Product Change Notification

Change Notification #: 113292 - 00
Change Title: Intel® Server System R1208GZ4GC
PCN 113292-00, Product Design
Update the System Rear Panel
Date of Publication: October 13, 2014

Figure One

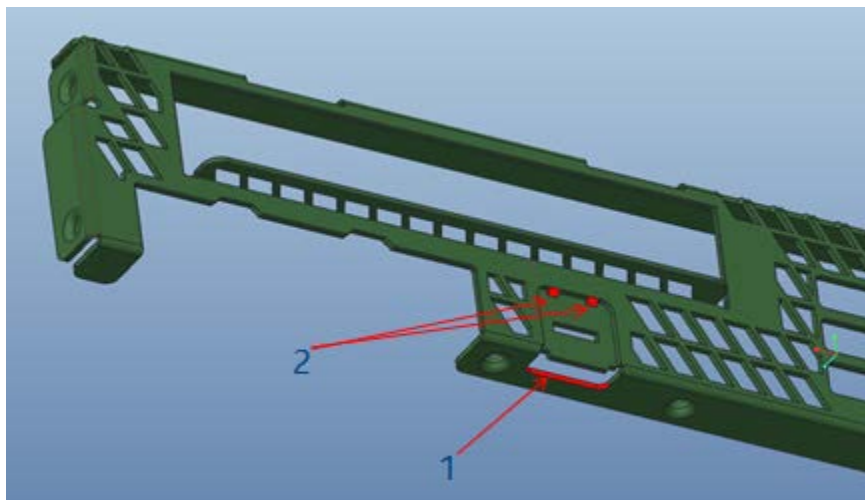
1. Add a connection at the bottom of the RMM4 (Remote Management Module 4) slot to improve structure strength. See item 1 in the Figure One.
2. Update the one big center joint to two smaller joints so that the joints will not conflict with the LAN cable connector latch. See item 2 in the Figure One.

Figure Three

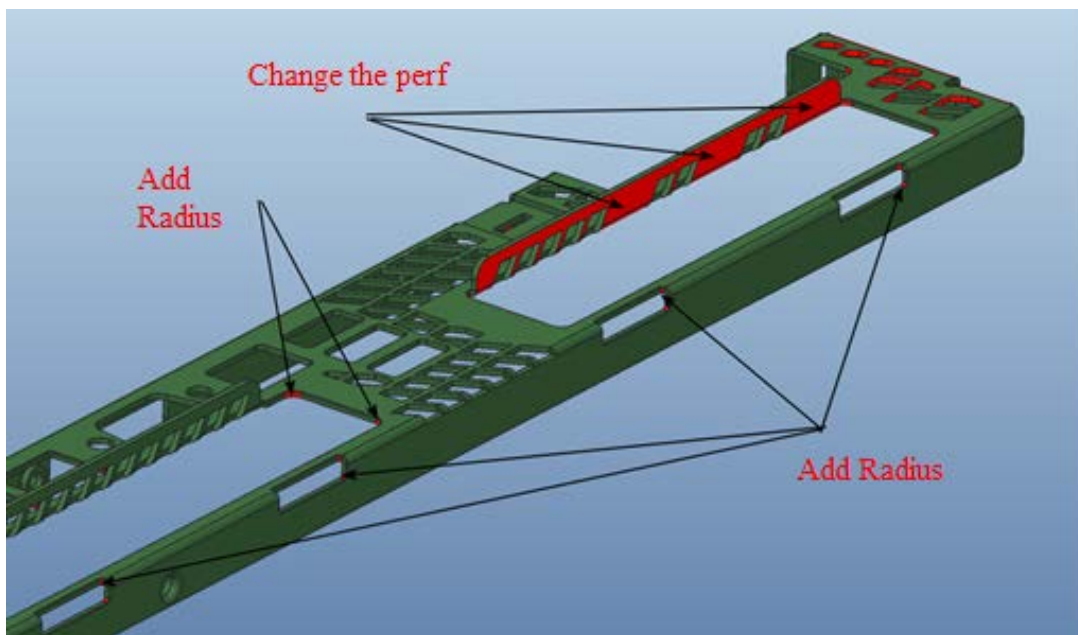
4. Update the perf and add radius to improve structure strength. See the Figure Three and Four.

Figure Five

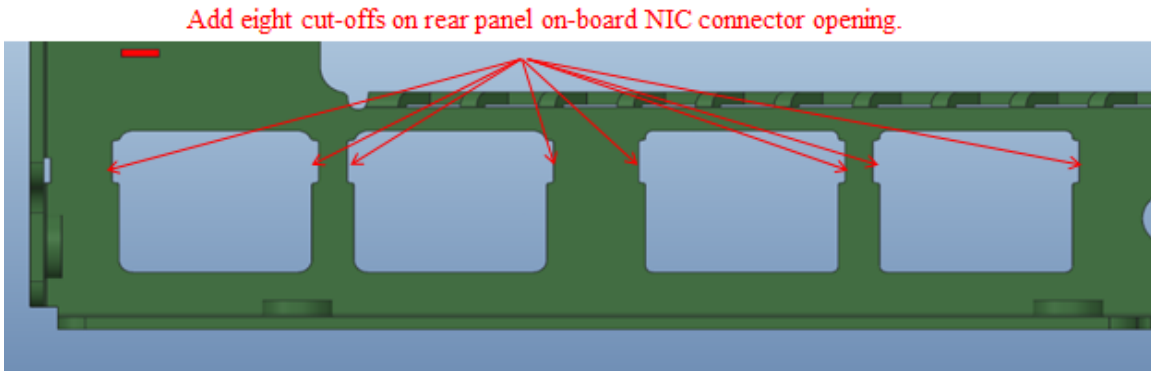
5. Add eight cut-offs around the on-board NIC (Network Interface Controller) openings to improve the LED visibility. See the Figure Five.
